Rezoning Transportation Analysis

Petition Number: #2023-020

Date	Description
6-28-23	First Review (PDM)

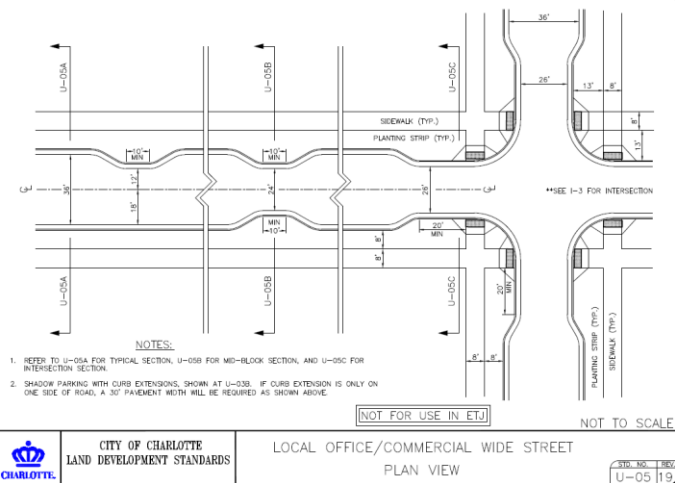
- Morehead Street:** Location of curb and gutter to be moved to 38 feet from roadway centerline to accommodate the Charlotte Streets Map with a roadway typical section of a four plus avenue with buffered bike lanes.

- Myrtle Avenue:** Location of curb and gutter to be moved to 20.5 feet from roadway centerline to accommodate the local commercial wide street typical section with on street parking (CLDSM U-05 Series).
